AMENDMENT NO. 1 MARCH 2026

**IS 18258 : 2023 EVALUATION OF TYRES WITH REGARD TO
ROLLING SOUND EMISSIONS AND/OR TO ADHESION ON WET SURFACES
AND/OR TO ROLLING RESISTANCE**

FIG. 4 NOMENCLATURE EXPLANATION RELATED TO GRIP INDEX OF THE TYRE

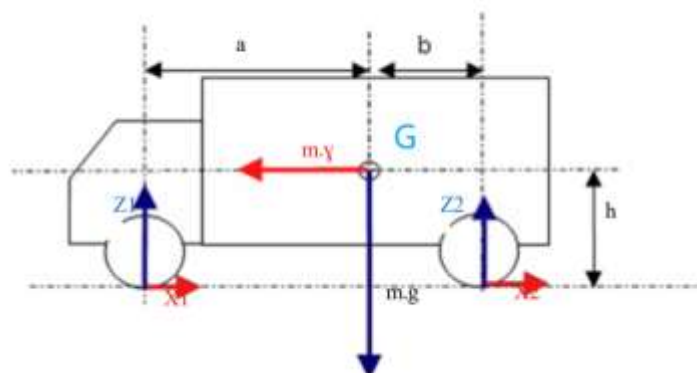
(Page 37, Fig. 4) — Substitute the following for the existing:
